**From:** Robert Reineke <rreineke@ksinghengineering.com>  
**Sent:** Friday, April 30, 2021 12:13 PM  
**To:** Pfeiffer, Jane K - DNR; Daniel Pelczar  
**Subject:** RE: Community Within the Corridor - East Block (02-41-263675) - Additional Information Requested for Site Investigation Work Plan (SIWP)

### *I. Source identification (scoping the investigation)*

II. Addressing previous investigations during future site investigation activities (scoping the investigation and work plan development) Wis. Admin Code § NR 716.09(2)(f)(8) requires a discussion of how sampling results will relate to results of any previous investigations.

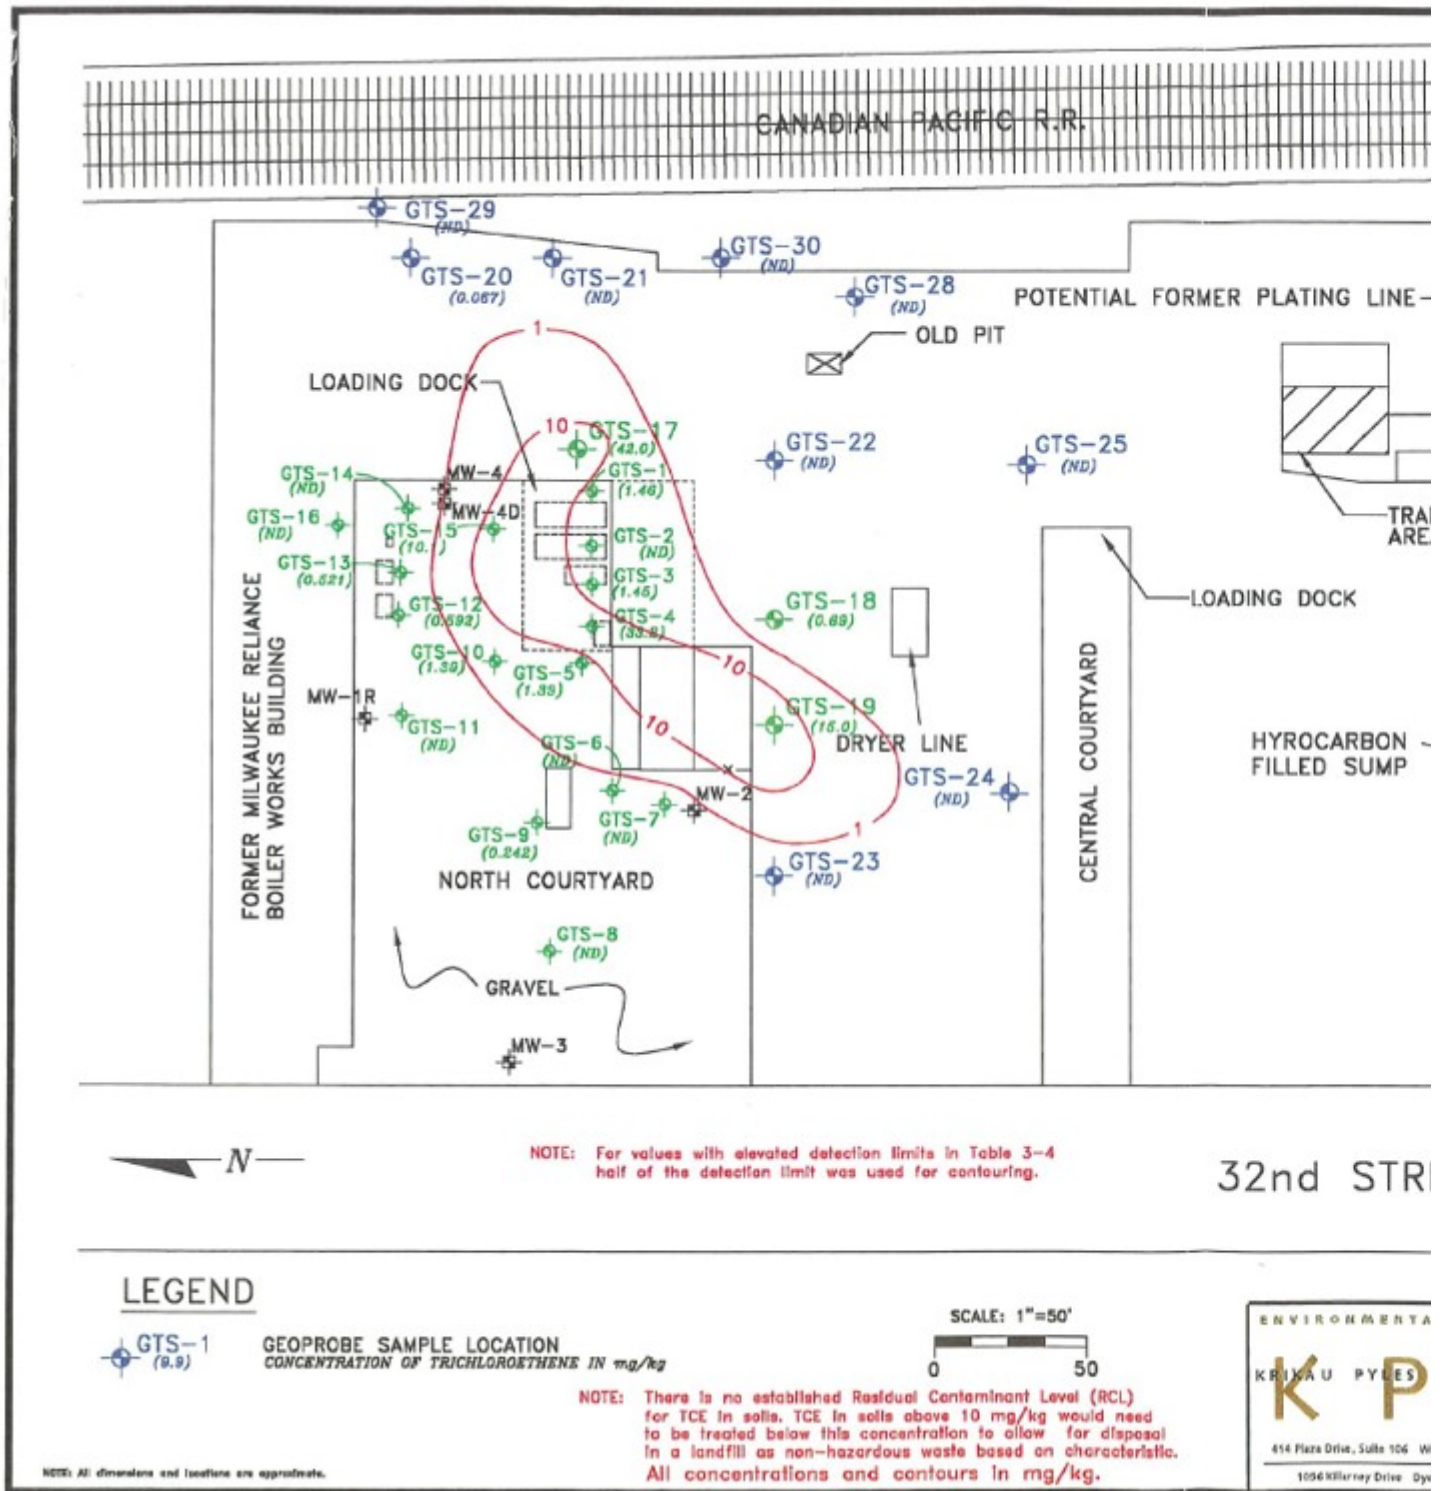
*A. Discuss the widespread distribution of trichloroethylene (TCE) related to a conceptual site model. Discuss potential sources and source areas of TCE at this site. Given the presence of high moisture content clay soils beneath the building, it appears unlikely that there was widespread migration through vapor and/or groundwater from a single release/source area.*

KSingh concurs that there have likely been several source areas of contamination. Based on soil sampling results, the TCE plume identified in the previous investigation encompasses Additions 7 (“1” Factory), 6 (transfer house), 5 (loading dock) 3 (loading area), 2B (packing plant), 2A (factory), and 8 (guard house). Source areas were the USTs in the northern courtyard, Addition 7, and Addition 2A.

For the remainder of the building, Addition 4 (Heat Treating Plant) was investigated previously with GTS-26 and GTS-27 performed in and adjacent to Addition 4 with no source detected. Heat treatment does not use TCE in processes.

Boiler House 1 and Addition 1 (coal house) are not considered sources of contamination as no factory activity occurred within the structures.

Building 1D (shipping shed) was utilized for loading and unloading rail cars and not for factory purposes. No source is suspected in this area.

Building 1B is the historic factory where the majority of detected TCE was found during the current soil sampling. Building 1B is considered a source area due to historic factory operations in this area. TCE sources may be found throughout Building 1B.

Building 1C (shipping shed) was utilized for loading and unloading rail cars and not for factory purposes. No source is suspected in this area.

Building 1A is a historic office building. No source is suspected in this area.

1928 Sanborn

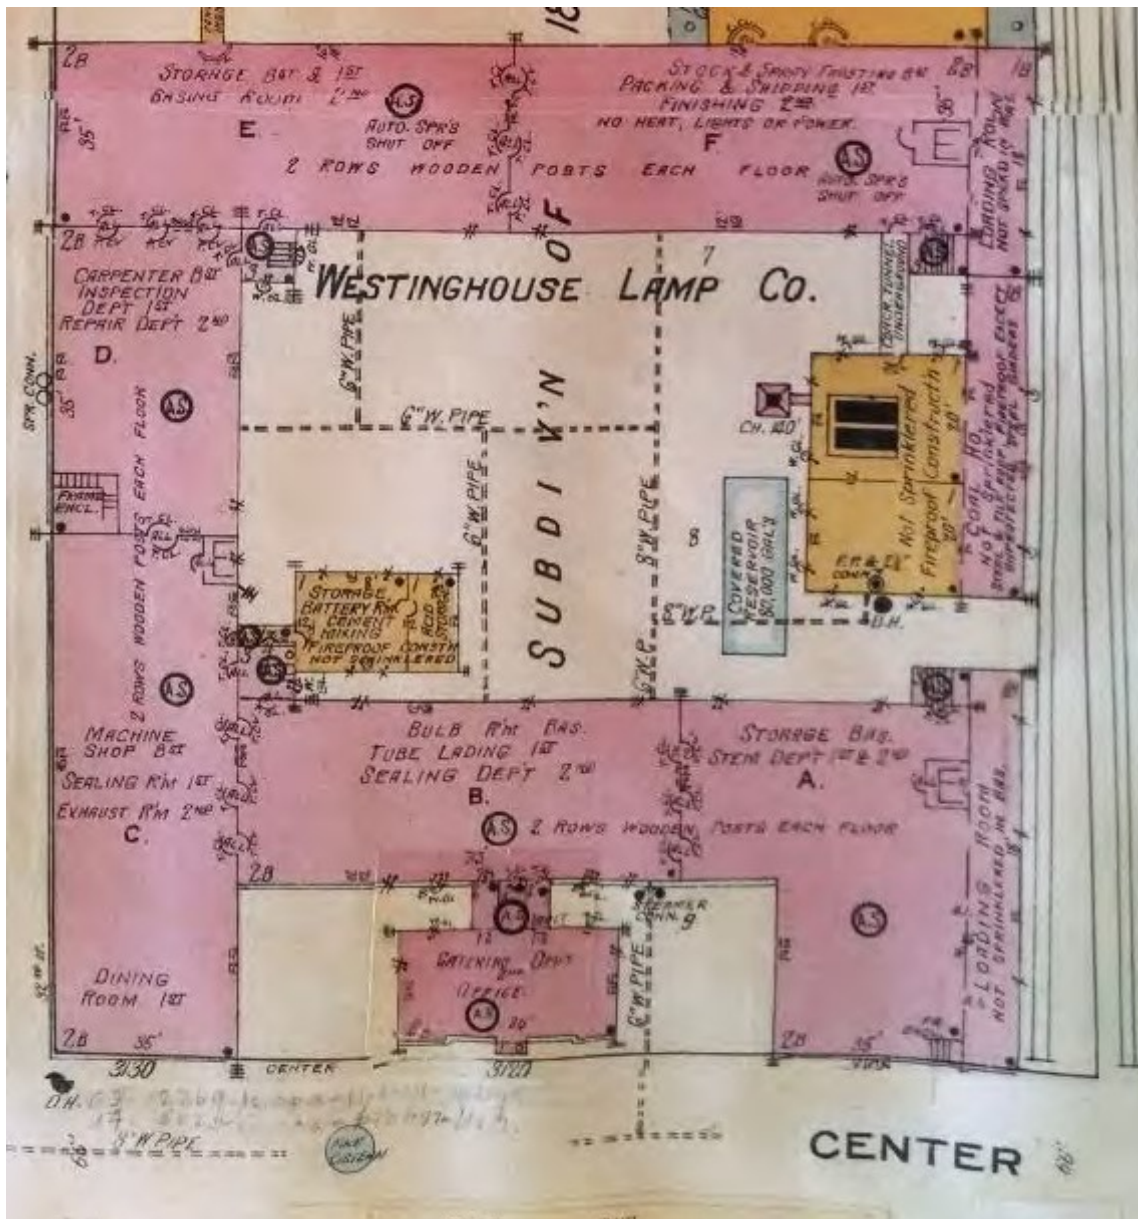
*B. Considering the historical use of the site, discuss whether there were degreasing stations throughout the building, and if possible, discuss the specific locations of these stations. Incorporate interviews from the Phase I ESA in your discussion, as applicable.*

As discussed above, buildings 1B, 2A, 2B, and addition 7 are suspected source areas of TCE where manufacturing was performed. Building 1B was the only suspect area that was previously uninvestigated. Sanborn maps don't identify

specific degreasing stations, but building 1B W and 1B SW are identified as having historic painting and machine shop uses. These were the locations where the greatest concentrations of TCE were encountered.

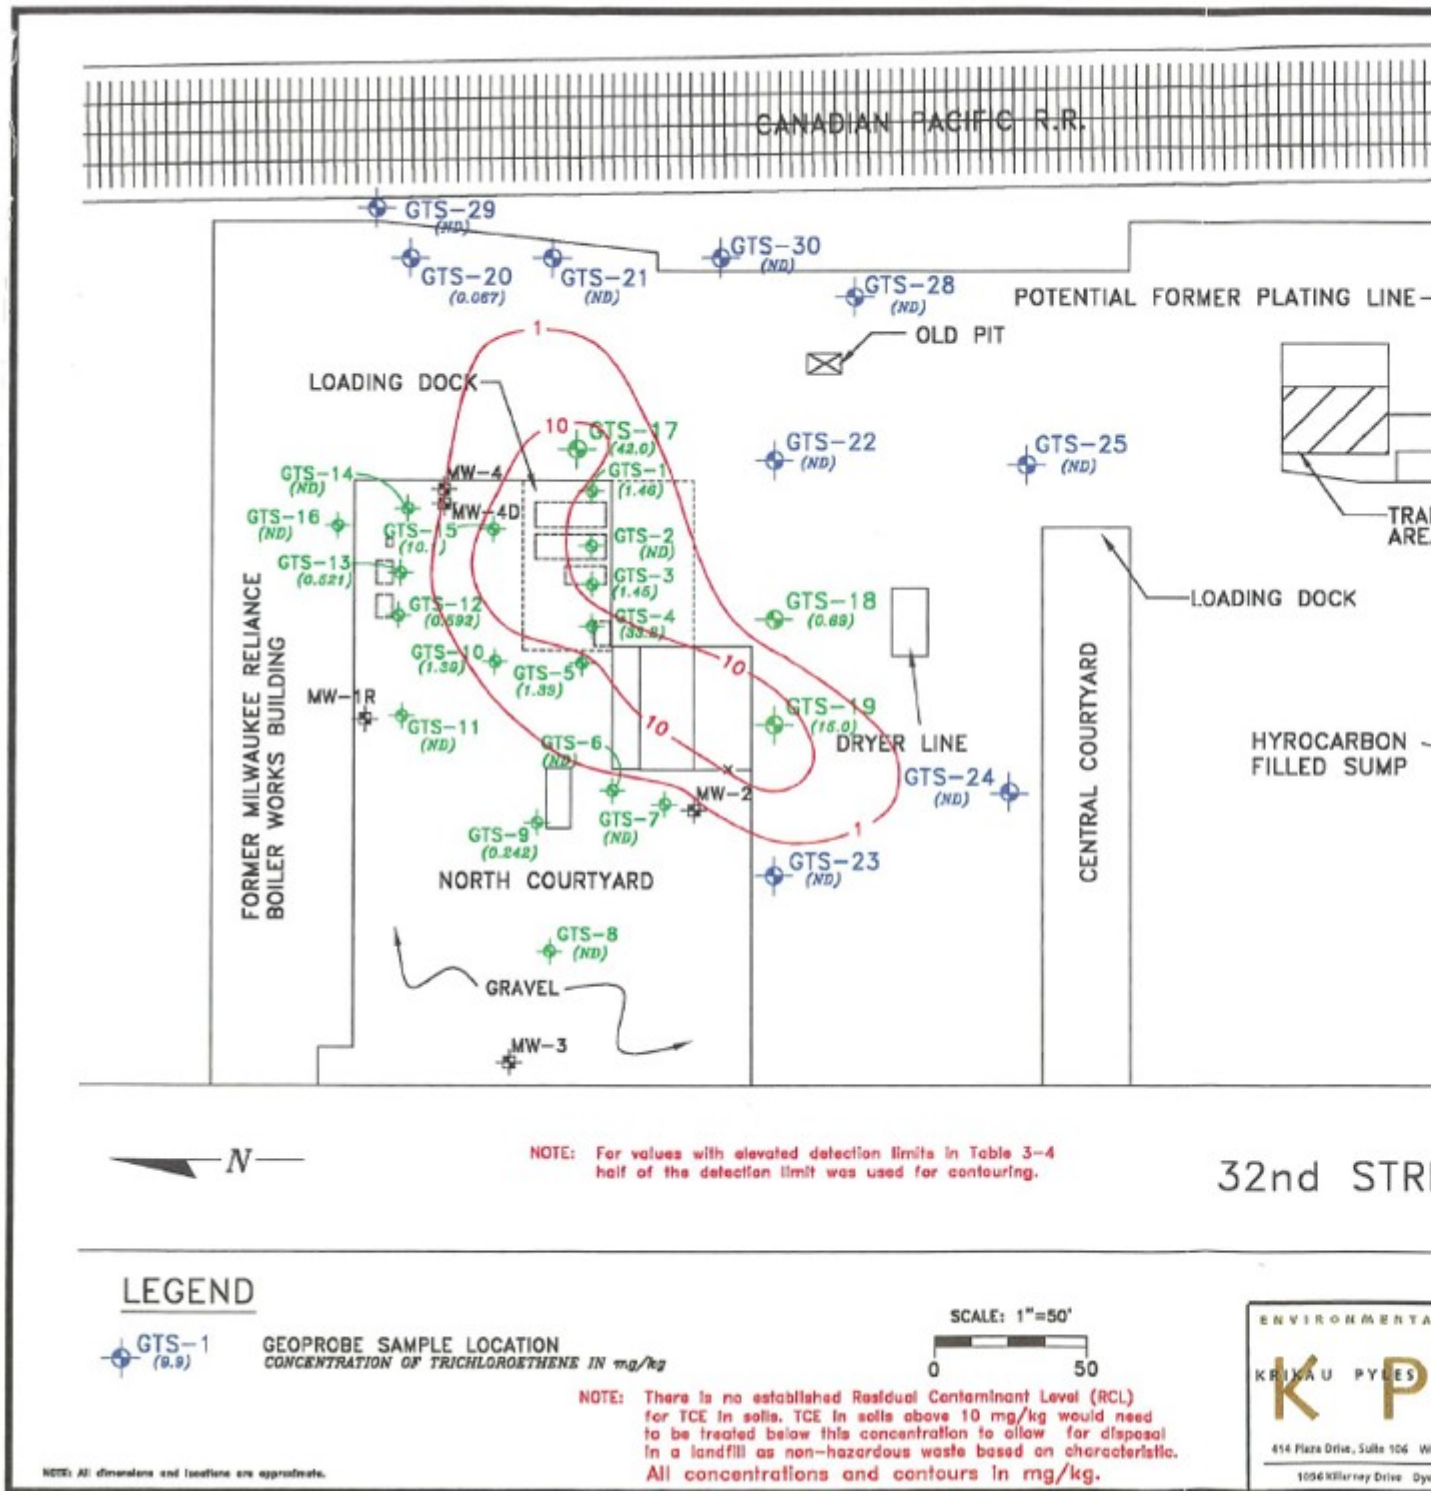
A. Provide historic site figures showing the location of contamination associated with the historic site investigation conducted prior to the 2008 case closure. Discuss the potential new sources of contamination as they may relate to previous investigations.

As discussed above, the historic investigation did not include Building 1B. See below for the historic figure included in the SIWP.

8 soil samples have been collected in building 1B and the greatest concentrations of TCE were encountered in the West and Southwest portions of building 1B.

Soil borings WB-B-MW-4, EB-B-20, EB-B-21, EB-B-22, EB-B-24, & EB-B-25 with associated monitoring wells are designed specifically to delineate the extent from sources in Building 1B with interior soil samples providing information on the magnitude of contamination.
